REFERENCE:	TSB: 08-117-25 REV. A GROUP: 08 - Electrical	Date:	May 20, 2025	REVISION:	08-117-25
VEHICLES AFFECTED:	2025 (DT) RAM 1500 Pickup This bulletin applies to vehicles equipped with Smartphone As A Key Capable (Sales Code GX6).	MARKET APPLICABILITY:			
		<input checked="" type="checkbox"/> NA <input type="checkbox"/> MEA <input type="checkbox"/> SA <input type="checkbox"/> IAP <input type="checkbox"/> EE <input type="checkbox"/> CH			
CUSTOMER SYMPTOM:	Software Enhancements included: <ul style="list-style-type: none"> • **Removes keyless sharing.** • Apply Owner Pairing and Key Sharing. • Passive Entry and Passive Start Features. • Improve NFC entry timing from sleep state. 				
CAUSE:	SPAAK Software

This bulletin supersedes Technical Service Bulletin (TSB) 08-117-25, date of issue April 15, 2025, which should be removed from your files. All revisions are highlighted with ****asterisks**** and include a new software enhancement, updated national launch date and removed build date (not highlight by asterisks).

Fig. 4
Software Update Complete

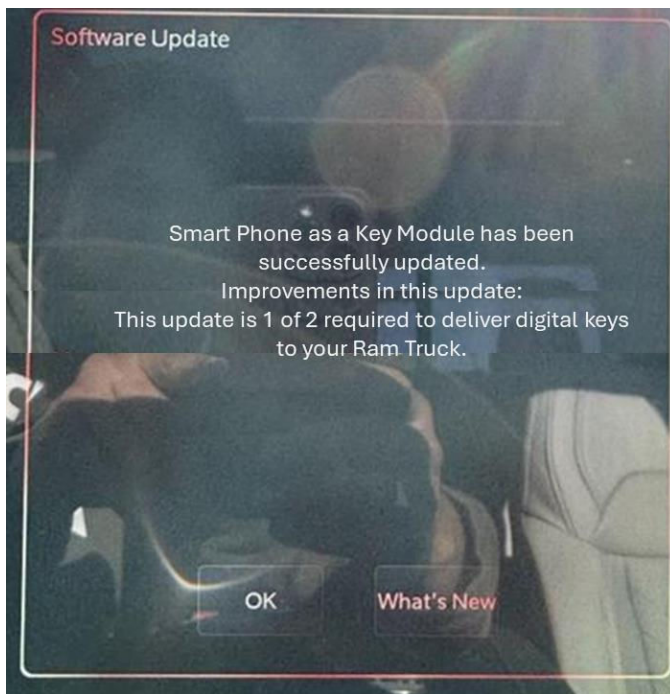
4. Upon completion of update, the radio display will display a confirmation message [Fig. 4](#).
